BAR Meeting  
July 27, 2016

**ISSUE:** Certificate of Appropriateness (alterations)

**LOCATION:** 1301 Queen Street

BAR2016-00232

**Figure 1: Staff proposed wood siding locations shown in red, based on BAR policy**

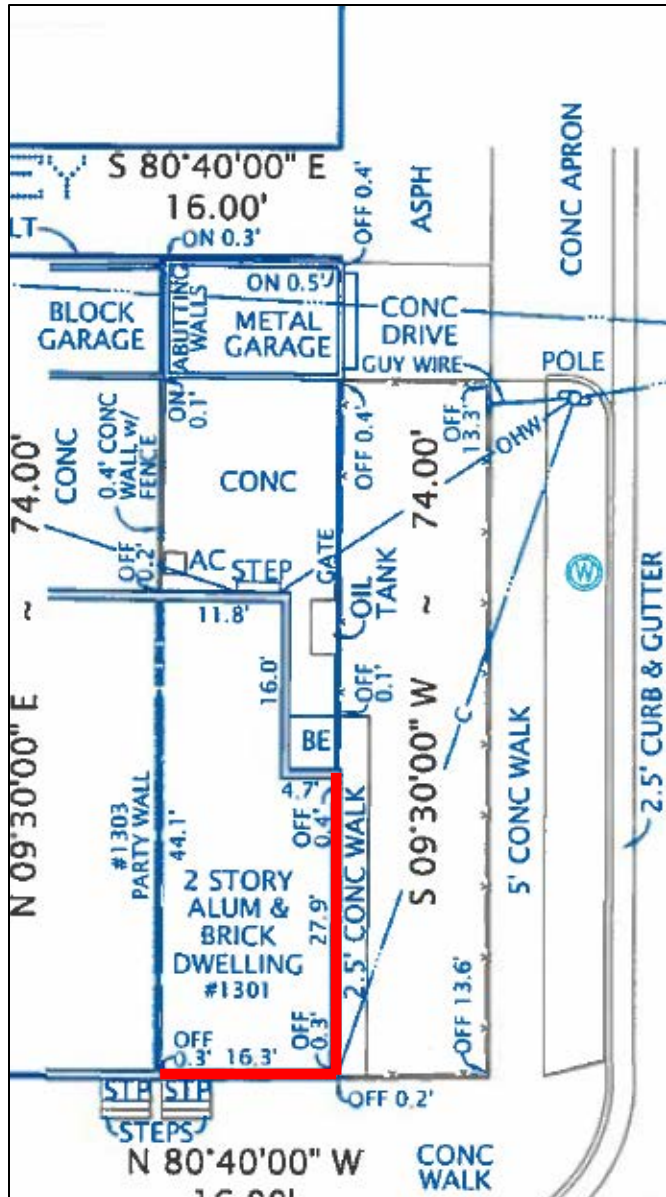
The applicant has not yet removed any portion of the aluminum siding, so staff has not been able to evaluate the existence, profile or condition of any original wood siding on the building. Based on other nearby structures constructed by the original builder, it is highly likely that all elevations of the original house were 1x6 German profile wood lap siding. From past experience, staff thinks that it is likely that a high percentage of the original wood siding could be in good condition and could reasonably be removed, sanded, primed and reinstalled on the house. Because there will be some damage to the historic siding during its removal and reinstallation, staff's usual practice is to recommend that material from the side/rear be used to clad the entire front, as proposed. New material to match the historic siding is then used on secondary elevations to complete the wall. In this case, there may be sufficient salvaged siding to also use on the entire east elevation of the main block (figure 1). Whether it is salvaged or not, staff recommends that both south and east street facing elevations of the main block of this Early house be wood siding.

Staff has no objection to the use of the proposed fiber cement siding on the north facing side elevation, as permitted by the Residential Reference Guide, or on all elevations of the rear ell.

1. The south and east elevations of the main block of the house be clad with wood siding salvaged from this dwelling, if reasonably possible, or with new wood matching the profile of the original material, as confirmed by staff in the field;
2. The north elevation of the main block, as well as the rear ell, may be clad with smooth fiber cement siding;
3. The existing front windows be repaired and restored in consultation with BAR staff;
4. The replacement windows on all elevations but the front façade must meet the *Alexandria Replacement Window Performance Specifications* contained in the BAR's adopted window policy and the new exterior trim must match the original.

### Proposed Front Elevation

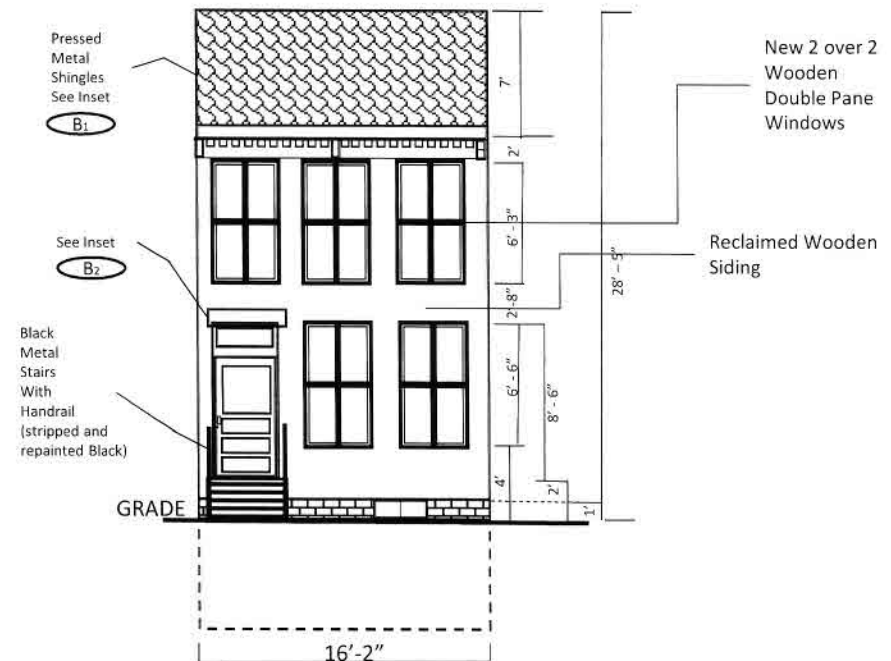
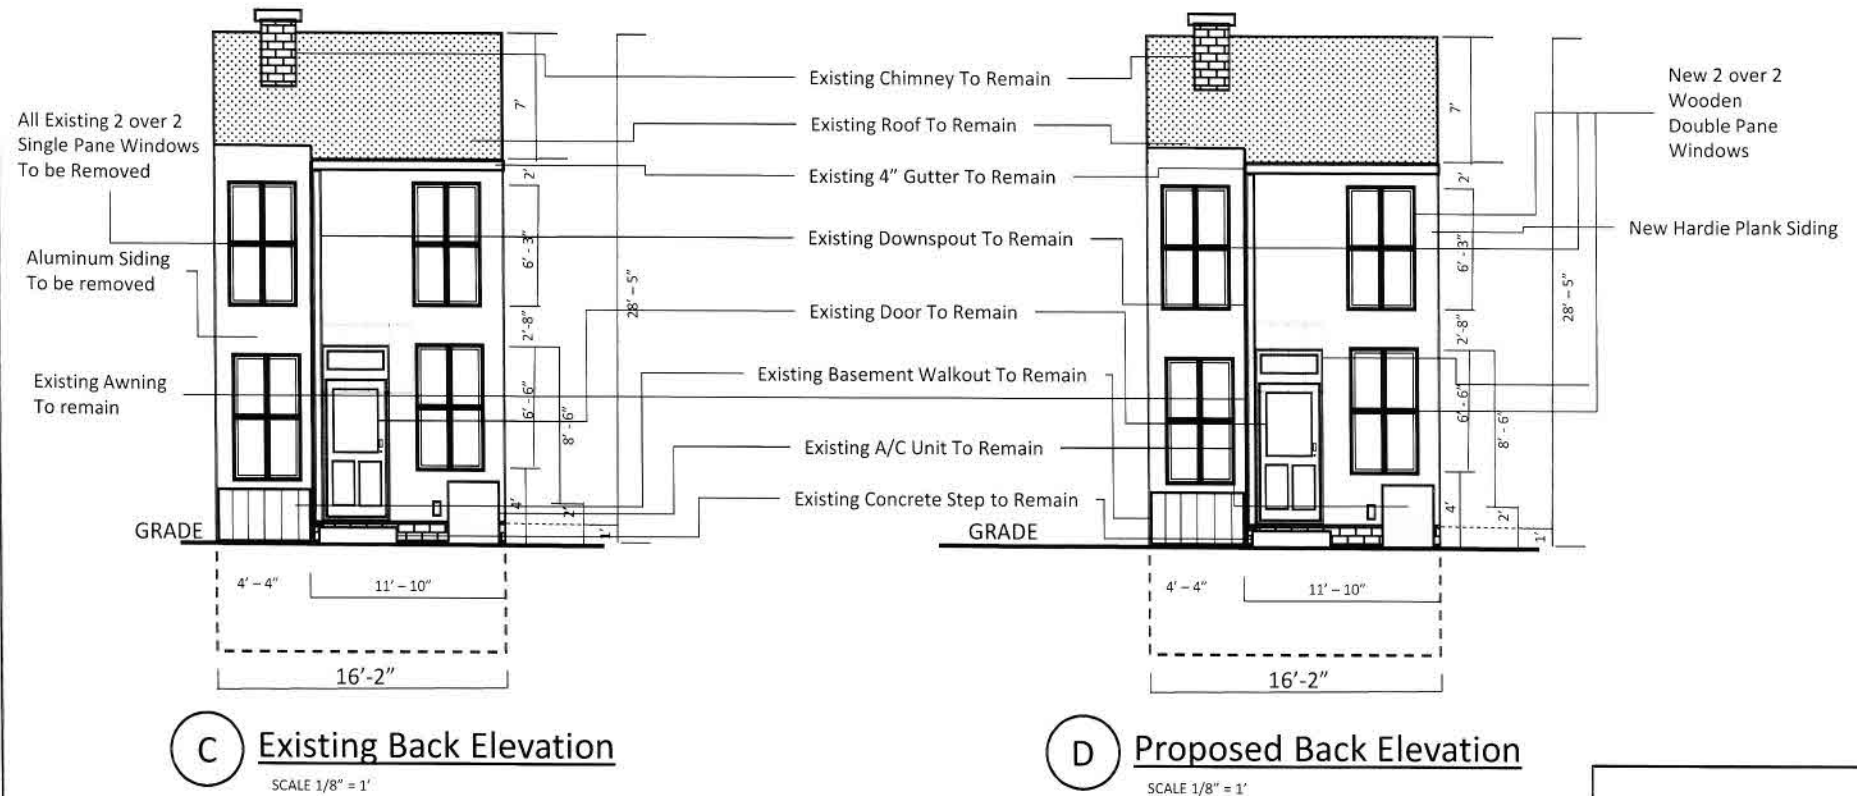
While the house likely did not have a door hood originally, staff has no objection to the addition of one on this house, as decorative door hoods are a common feature on Italianate style townhouses. After looking at some of the other nearly identical townhouses constructed by the same owner, some have had porticos or door hoods added (figure 2). The Board has approved new door hoods in other instances as well, most recently at 1022 Oronoco Street (figure 3). The door hood is a rather small feature that can be easily removed if desired in the future with little impact to the historic house.
